NATIONAL TRANSPORTATION SAFETY BOARD
Office of Aviation Safety
Washington, D.C. 20594

November 12, 2018

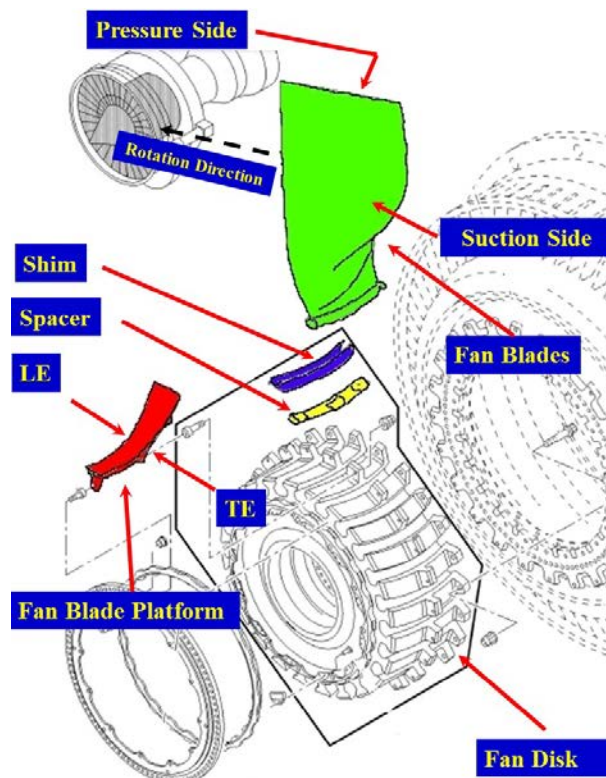
⁴ Although the root of the fan blade is technically comprised on the airfoil shank and dovetail, the airfoil shank is commonly referred to as simply the root. For purposes of this report, the airfoil shank and root can be used interchangeable and the dovetail will be used to reference that part of the fan blade root that slides into fan blade disk. See **FIGURES 18-20** and footnote 20 for additional clarification.

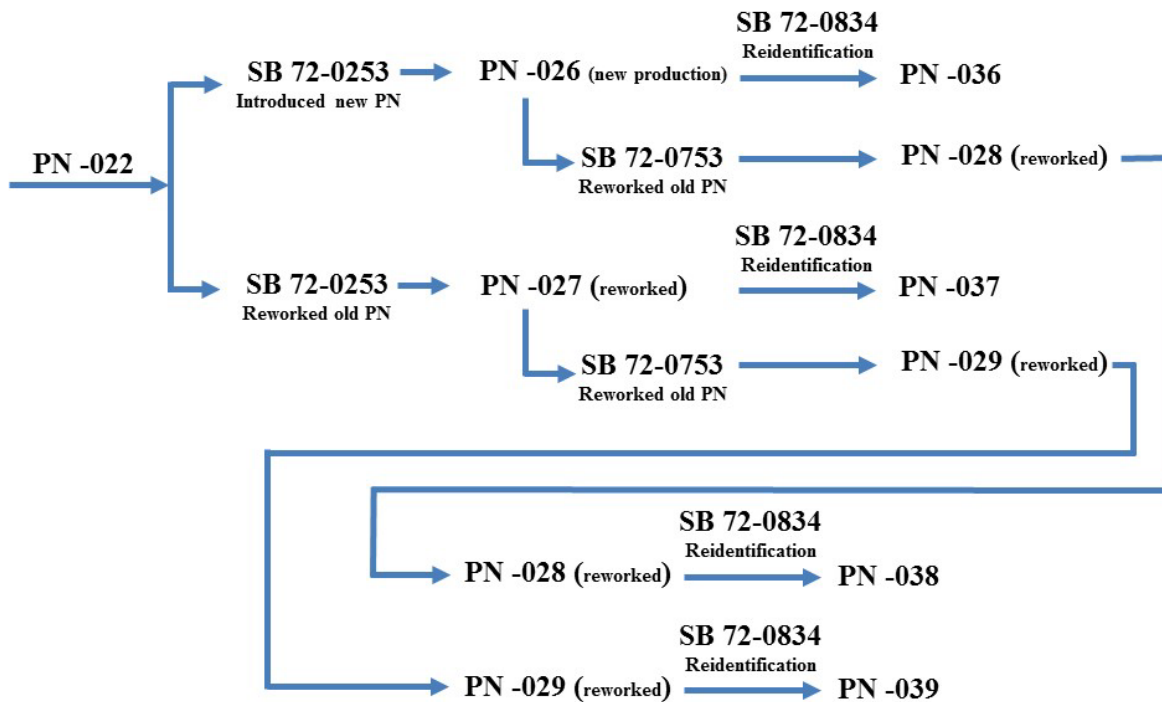
For engines that have accumulated more than 15,000 FC since last shop visit at the issue date of this service bulletin, do this service bulletin not later than 6 months after the issue date of this service bulletin.
